PUBLIC UTILITIES COMMISSION

July 11, 2017

RE: Sycamore- Peñasquitos 230-kV Transmission Line Project— Review of Minor Project Refinement #5 Request

Exhibit 1: MPR #5 Maps

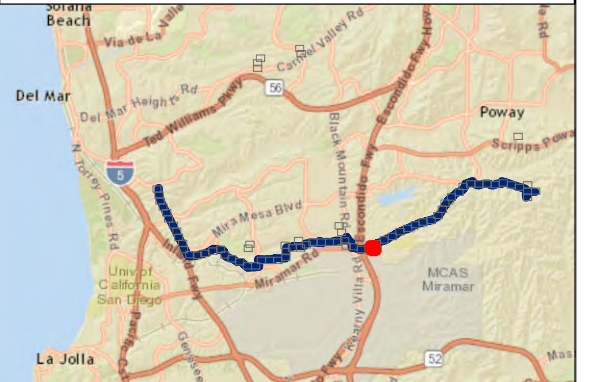
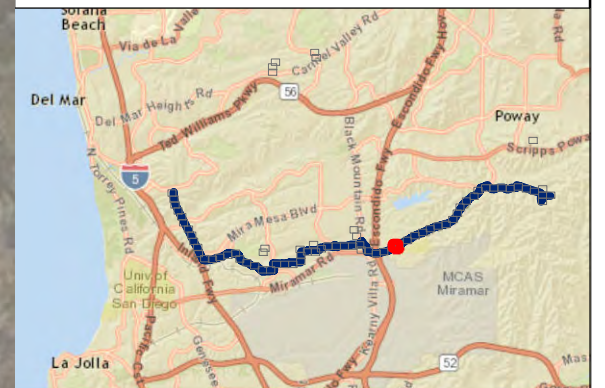
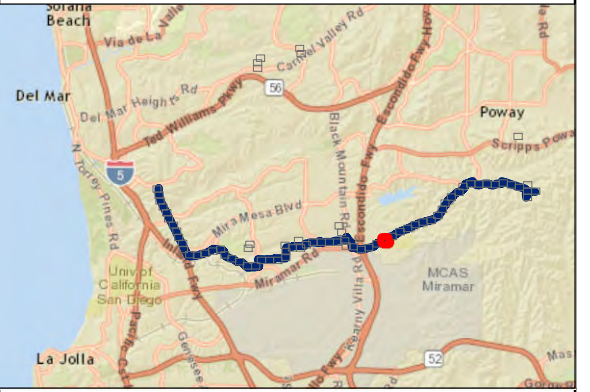
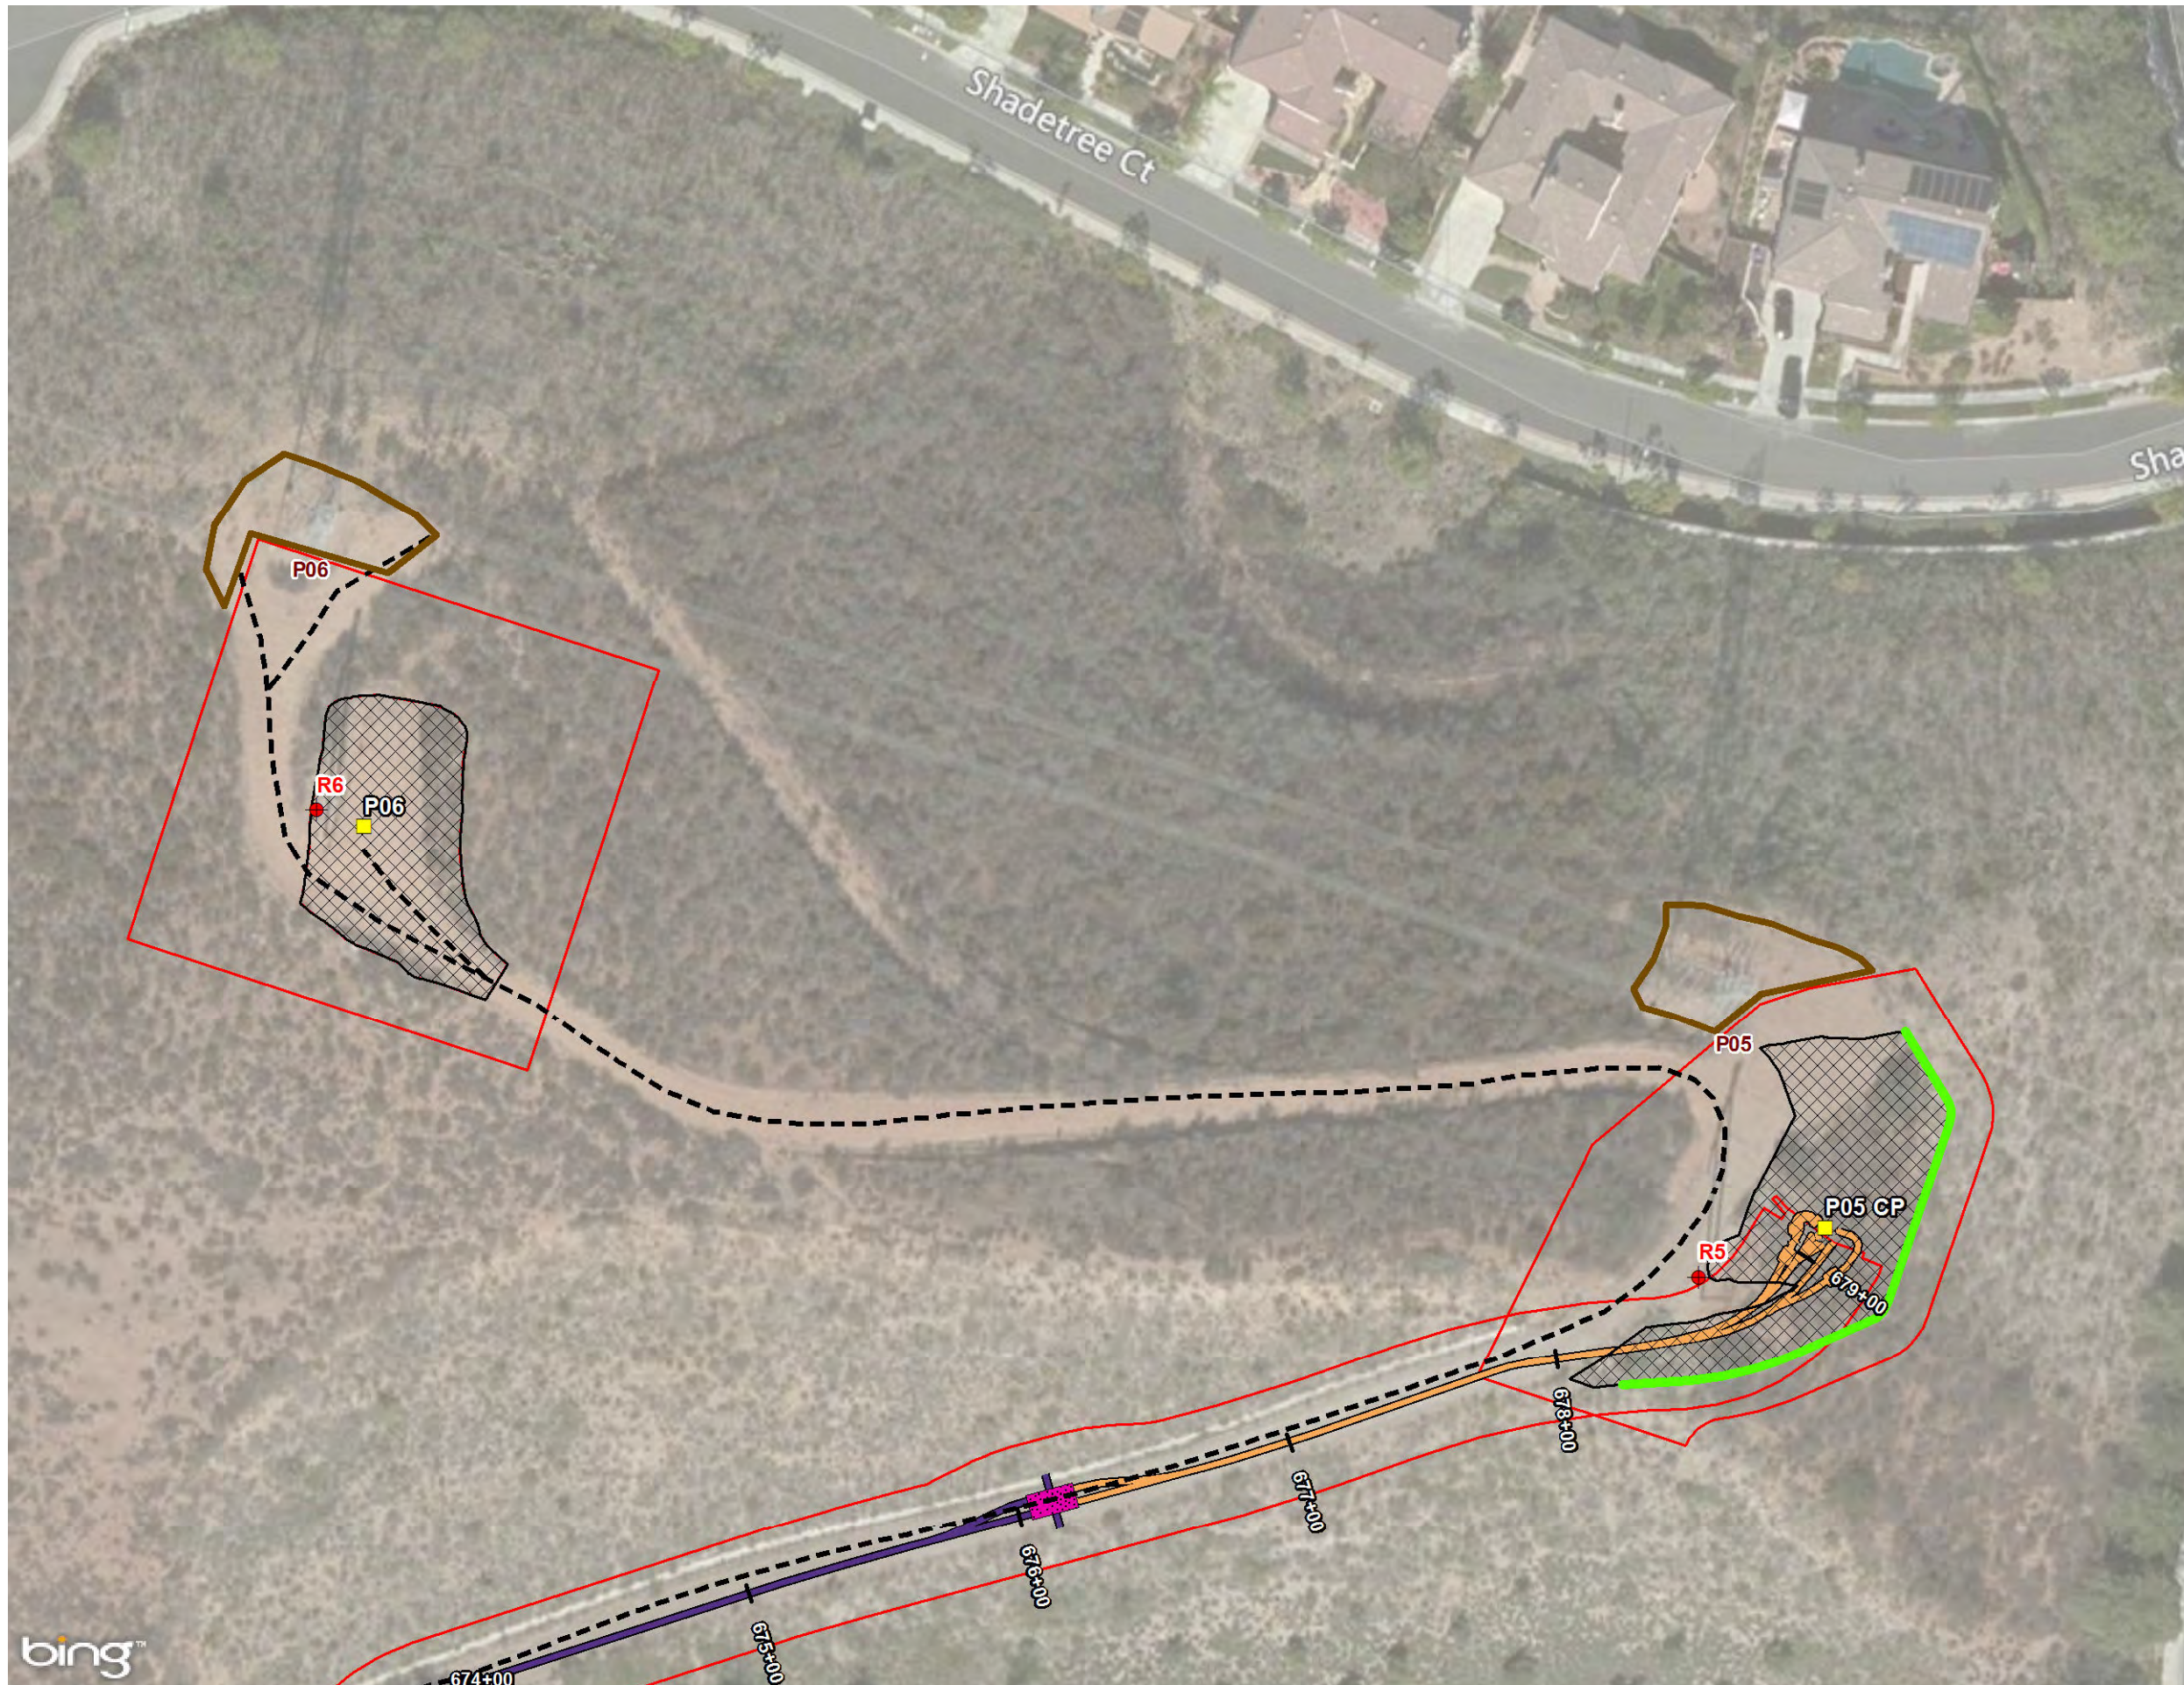
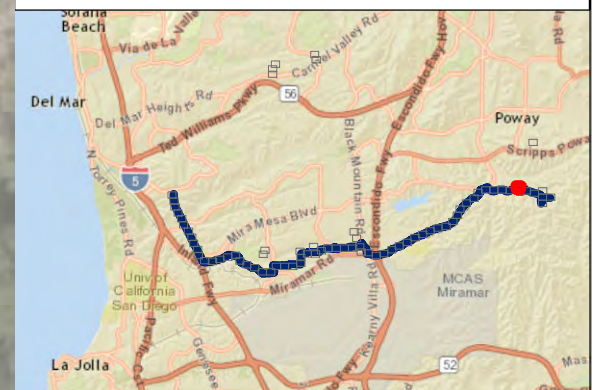
On July 10, 2017, SDG&E submitted Minor Project Refinement (MPR) #5 for approval by the California Public Utilities Commission (CPUC) for the Sycamore-Peñasquitos 230-kV Transmission Line Project (Project). MPR #5 establishes staging yards along the southern perimeter of Pomerado Road and temporary work spaces north of P05 and P06, which are shown in Exhibit 1 (attached).

Under this proposed Minor Project Refinement (proposed refinement), SDG&E seeks to add additional temporary work space (as identified above and in Attachment 1), totaling approximately 0.31 acres, along the southern perimeter of Pomerado Road. In addition, SDG&E seeks to expand the existing approved temporary work spaces surrounding P05 and P06 by a total of approximately 0.1 acre. The use of these areas would not result in any new impacts or increase the severity of a previously analyzed impact as identified in the Project's FEIR and as authorized by Notice to Proceed (NTP) #2 issued by the CPUC on February 7, 2017. No ground disturbing activities are proposed; however, minor vegetation clearing and trimming is proposed (brush, weed, and non-native grasses) as needed to minimize potential fire risk.

Areas with native vegetation will be flagged prior to use of the staging areas. All staging areas will be clearly delineated with lathe staking and flagging to ensure construction personnel stay within approved project limits. The additional work space located north of P05 contains individuals of scrub oak (*Quercus dumosa*) located along the perimeter of the workspace that will be flagged for avoidance.

2. Copies of all relevant permits, compliance plans, and this MPR, shall be available on site for the duration of construction activities.
3. Proof of City of San Diego approval of staging locations 1-4 shall be provided to the CPUC prior to use of these areas.

13. The canopy driplines of individuals of scrub oak (*Quercus dumosa*) located along the perimeter of the P05 workspace will be flagged for avoidance.

14. All staging areas will be clearly delineated with lathe and flagging to ensure construction personnel stay within approved project limits. Portions of staging areas and workspace that support native vegetation will be flagged for avoidance prior to use of the staging areas.
